**ADDENDUM NO. 1 TO ALL BIDDERS:**

Invitation to Bid: **ITB No. SOL1254**

Description: **Public Works Service Center and Fire Stations 4 & 6 Fueling Improvements**

**ATTACHMENT A TO**  
**ITB NO. SOL1254**  
**PUBLIC WORKS SERVICE CENTER AND FIRE STATIONS 4 & 6 FUELING IMPROVEMENTS**  
**REVISED DRAWINGS**

SHEET NUMBER:  
**E601-PW**

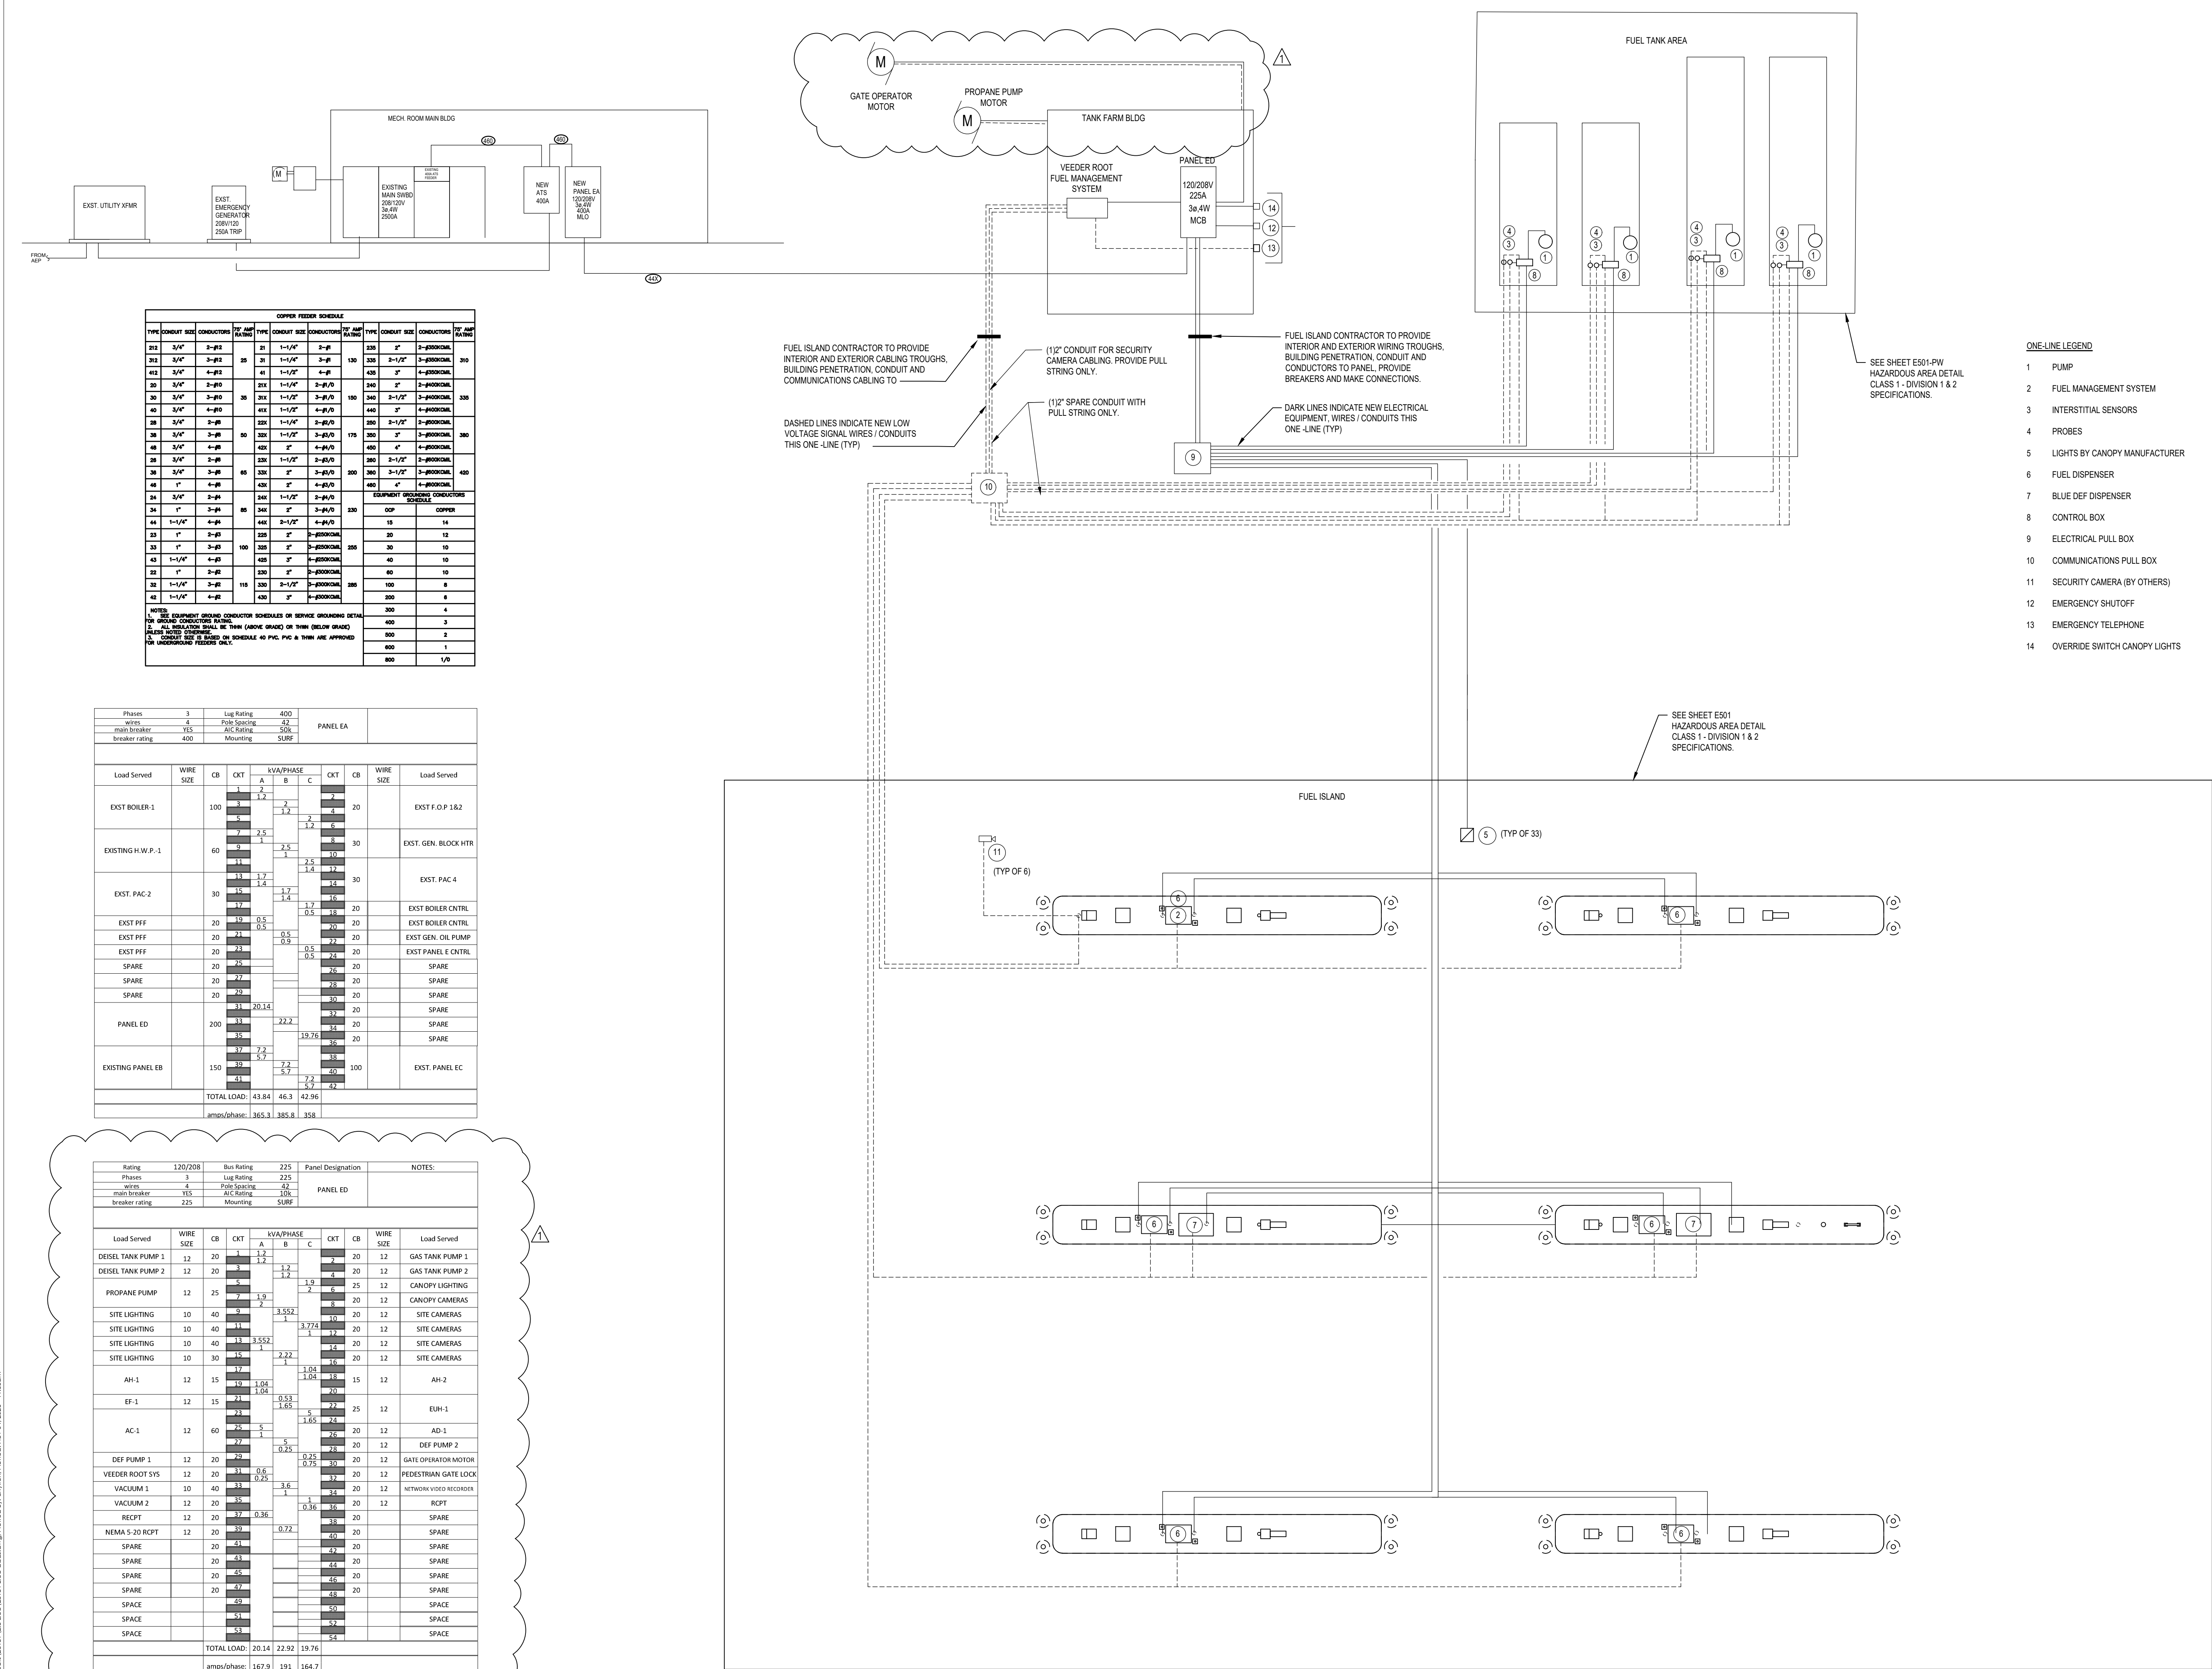
E601-PW	ELECTRICAL – ONE-LINE DIAGRAMS & PANEL SCHEDULES	<ul style="list-style-type: none"> <li>• One-line Diagram modified to show gate connections.</li> <li>• Panel ED modified.</li> </ul>
